# Product Change Notification

## 113742 - 00

**Change Notification #:** 113742 - 00  
**Change Title:** Intel® Server System R2312IP4LHPC  
PCN 113742-00, Product Design, Label  
Update the Power Distribution Board, Add a  
Rubber and a KCC Safety Label  
**Date of Publication:** March 24, 2015

Figure-1: Location of Capacitors C11 and C13

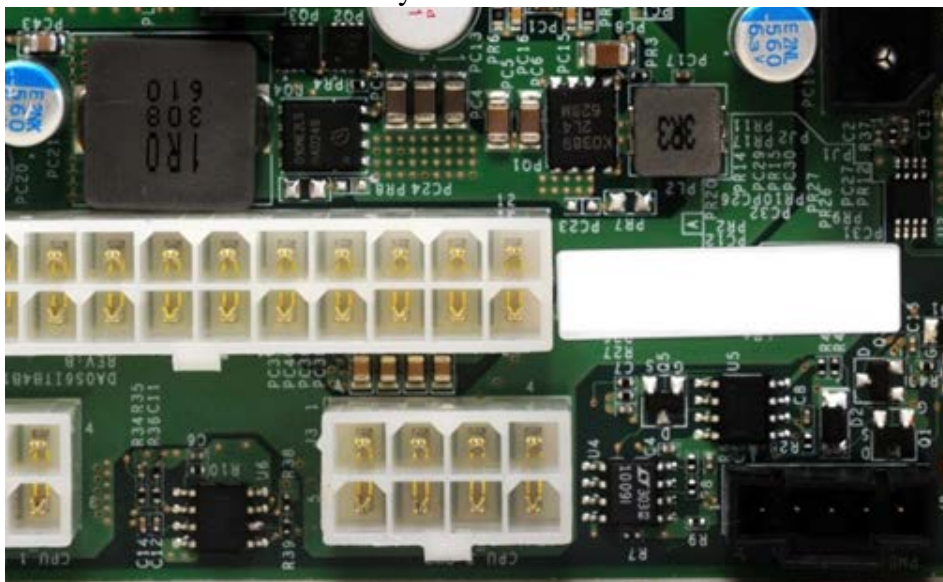
1. Increase the two capacitor values of C11 and C13 on the Spare Power Distribution Board (PDB) FBP750PDB from 0.1 $\mu$ F to 2.2 $\mu$ F to extend the duration of the Over Current Protection (OCP) circuit from 0.6ms to 8.0ms. This change prevents the potential system shutdown event triggered by the violation of the 240VA regulation of the OCP circuit.
